VALLEY CAMP OF UTAH, INC.

Re: NOV N84-7-6-1 Abatement Measures

FIGURE 1 STAGE CAPACITY CURVE FOR SEDIMENT POND

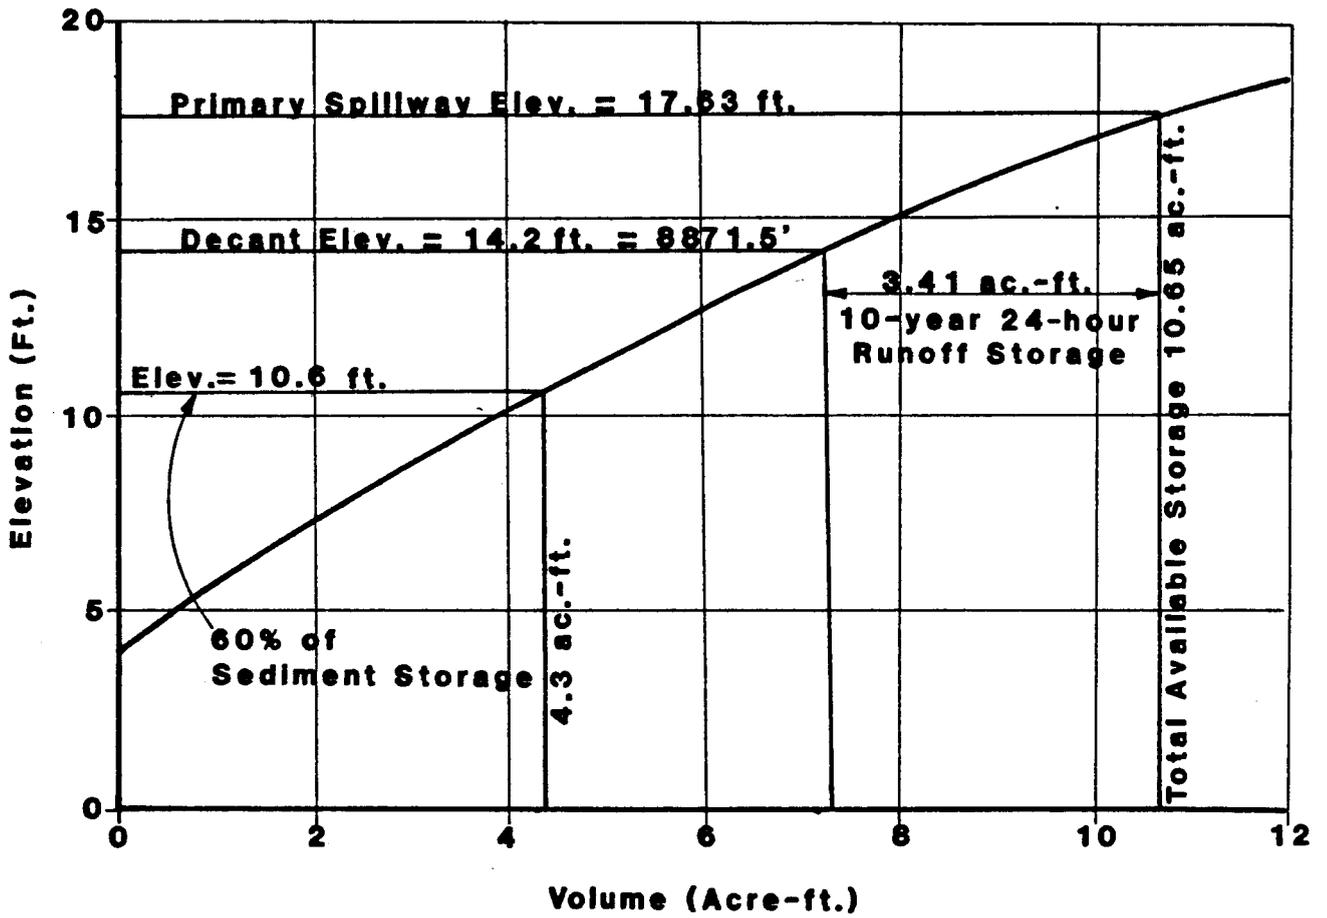
1. It is our intention to clean the sediment pond such that the stage capacity is equivalent to that proposed by Golder and Associates (see attached figure). The required runoff storage volume from the 10-year 24-hour event is 3.41 acre-feet. Therefore, as illustrated on the attached figure, the elevation of the decant orifice will be set at 8871.5 feet.

The original design of the pond, as presented by Golder Associates, was arrived at by calculating a required volume from the design storm (10 year 24 hour) of 6.7 acre feet for runoff, and 3.6 acre feet for sediment volume. This resulted in a total volume requirement of 10.3 acre feet.

In reviewing the Golder information and comparing it with the Vaughn-Hansen Compliance Report, I have found an apparent miscalculation. Using the same formulas as was used by Golder, but changing the required volume of sediment from 3.6 acre feet to 2.75 acre feet (27.5 disturbed acres vs 36.0), and using a new calculated water volume of 3.41 acre feet (as compared to 6.7 acre feet), I come up with a total volume requirement of 6.15 acre feet rather than 10.3 acre feet. Thus, as you can see, the pond as built was considerably oversized.

In consideration of this over-calculation and the amount of sediment we would be required to remove, in order to reestablish volumes as related to the 10.3 figure, I would ask you to consider requiring the removal of only that amount of sediment which would reestablish the sediment water and volumes required from proper sizing. Of course I would remove as much of the sediment as I could while the cleaning operation is in pro-
